TAG QUARTERLY PROGRESS REPORT

Date: July 27, 2005
Report Number: 9
Report Period: April 1, 2005 to June 30, 2005
Site: Pantex Superfund Site
Grant Recipient: STAND, Inc.
Recipient Group Rep: Pam Allison, Project Manager
Technical Advisor: IEER: George Rice

Evaluation of the Department of Energy's revised *Risk Reduction Rule Guidance to the Pantex Plant RFI*, March 2004
George Rice, March 2005

RE: Sands Springs Riverbank Sludge Removal
Rip-Rap Design
Sands Springs, OK

FIGURE 1

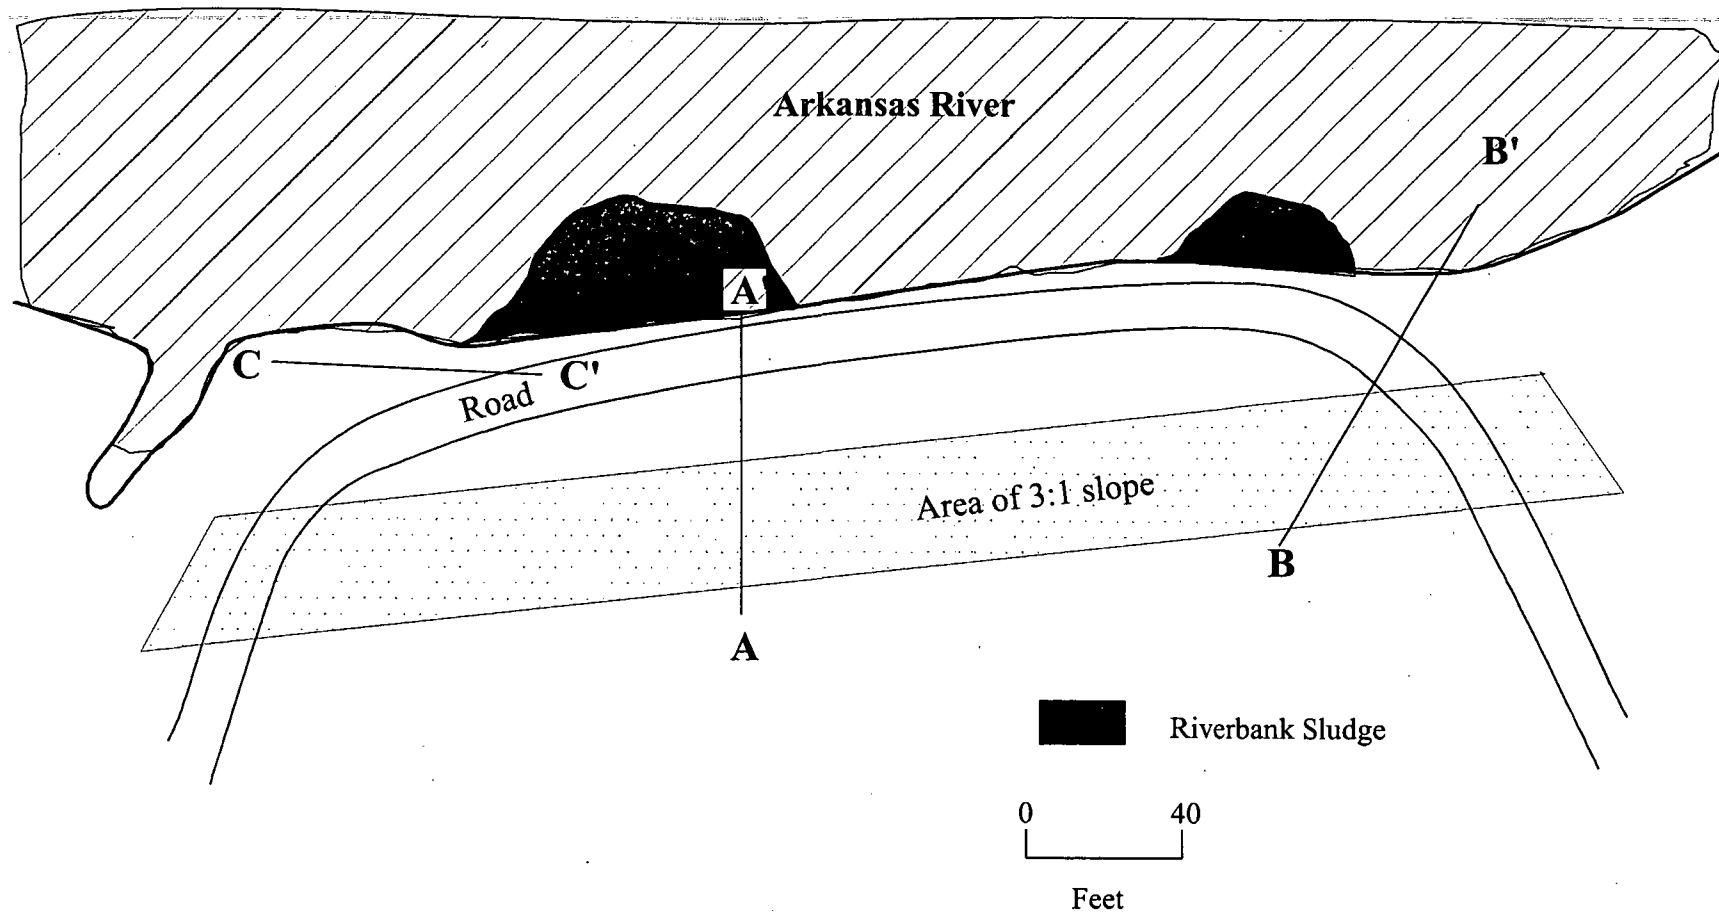
The current configuration of the Sludge Removal Area is shown on the attached Figures 1 and 2. The attached cross-sections in Figures 3 through 6 show the expected final geometries of the riverbank slope in the area subject to the sludge removal. These cross-sections show that the lower section of the slope immediately above the normal water level will be graded at slopes of 10H:1H or flatter. These areas will be backfilled with at least 2 feet of the compacted clayey shale material. The middle portions of the site have relatively smooth contours vertically and laterally as shown in Cross-Section A-A'. The lack of a steep slope along the riverbank should reduce the potential for localized turbulent flow that could cause scour. There will be a low slope "step" along the upstream edge that marks the transition from the fill and sludge removal area to the adjacent lowlands as shown in Cross-Section B-B'. Atlantic Richfield recognizes that this transition may cause localized scour forces that require additional protection as discussed below. Similarly, the downstream edge of the fill and sludge removal area is marked by an existing bluff as shown in Cross-Section C. This transition will also have additional protection as discussed below.

FIGURE 6

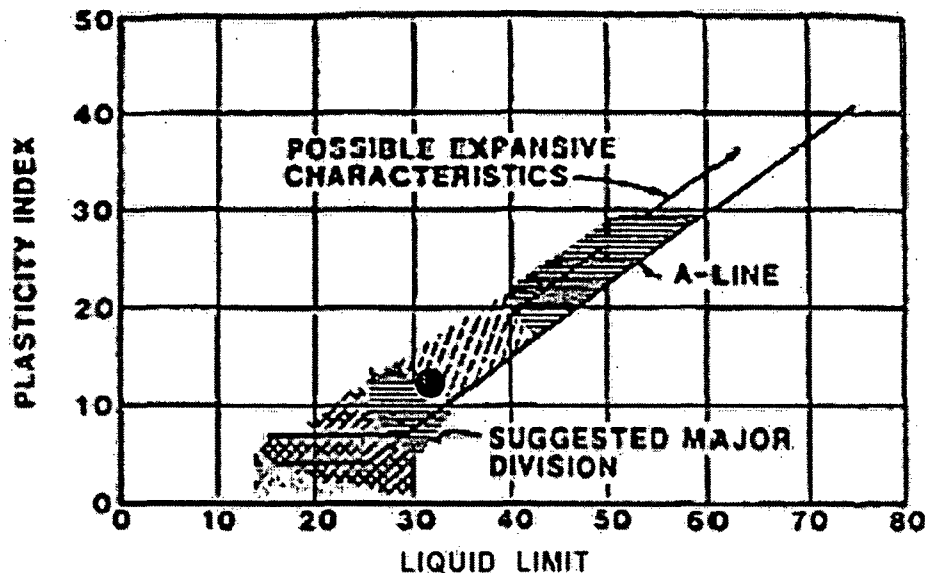
The off-site backfill source of clay provides an alternative approach to erosion protection. The attached laboratory test results show that clay is classified as a low-plasticity clay (CL) with the "highest resistance to erosion" as presented in the attached Figure 6 from USACE TM 5-818-8 *Engineering Use of Geotextiles*. The clay is expected to have a permissible velocity of about 6 fps compacted in place and up to about 8 fps if vegetated with grass or similar plants.
